TERMINAL WAREHOUSE

261 ELEVENTH AVENUE

DESIGN RESPONSES

TO COMMISSIONERS' COMMENTS FROM
DECEMBER 10, 2019 PUBLIC MEETING

NORTH ELEVATION (28TH STREET)
PROPOSED DESIGN - 10 DECEMBER 2019

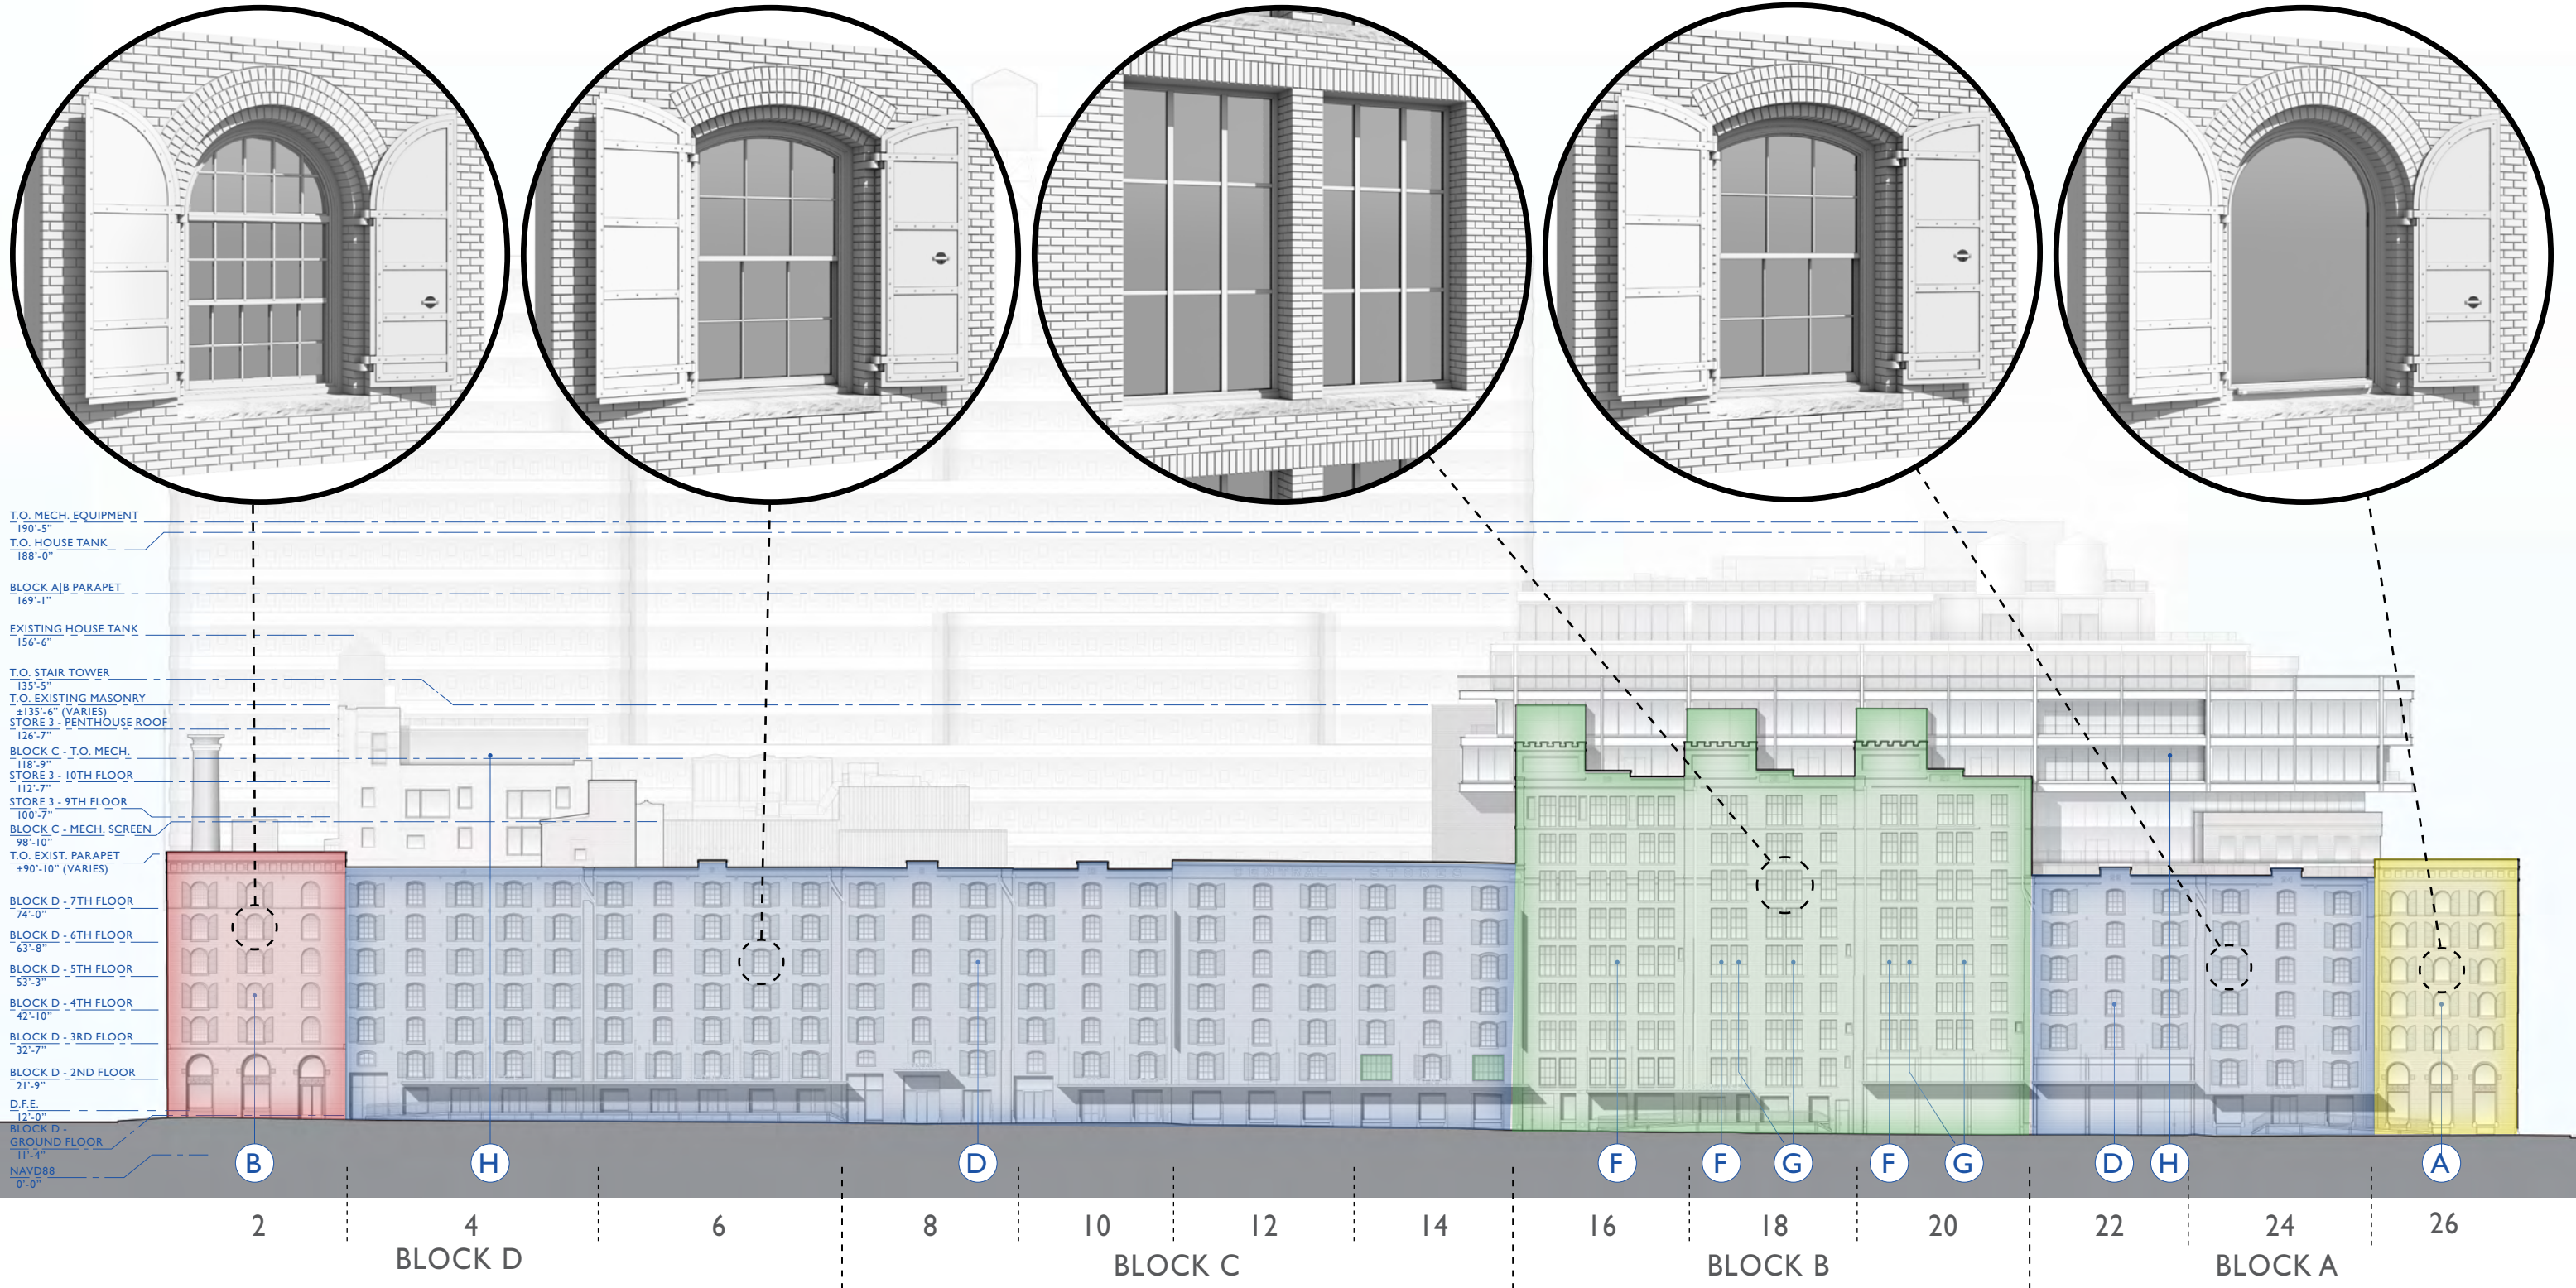
UPDATED DESIGN - 21 JANUARY 2020

HIGHLINE AT 31ST STREET
21 JANUARY 2020

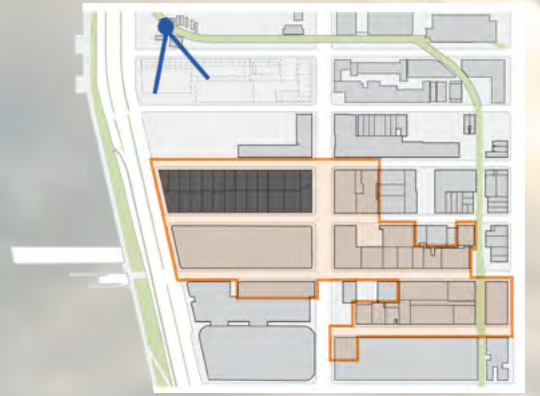
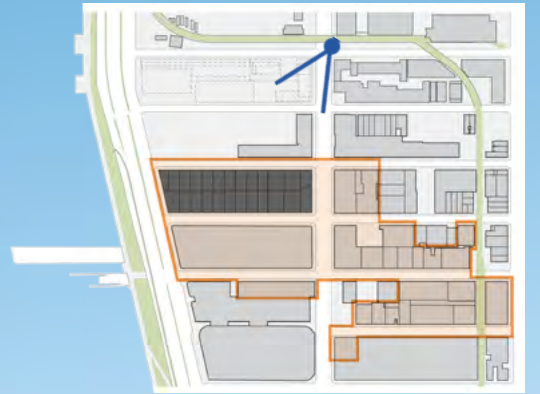
- 1. STAIR TOWERS CHANGED TO BRICK & STAIR TOWERS LOWERED TO MATCH HEIGHT OF EXISTING BULKHEADS ON NORTH FACADE
- 2. FLOOR PLATE SIMPLIFIED AT 12TH & 13TH FLOORS
- 3. EXTERNAL ELEVATOR TOWER REMOVED
- 4. CURTAIN WALL ARTICULATION OF 12TH & 13TH FLOORS CHANGED TO MATCH 10TH & 11TH FLOORS
- 5. BRISE SOLEIL REMOVED FROM 13TH FLOOR
- 6. WATER TANKS LOWERED, DUNNAGE SIMPLIFIED
- 7. BRISE SOLEIL REMOVED & EXTERNAL FRAME ARTICULATION ADDED TO 12TH FLOOR
- 8. SEGMENTAL ARCH WINDOWS CHANGED TO 6 OVER 6 DOUBLE-HUNG WINDOWS
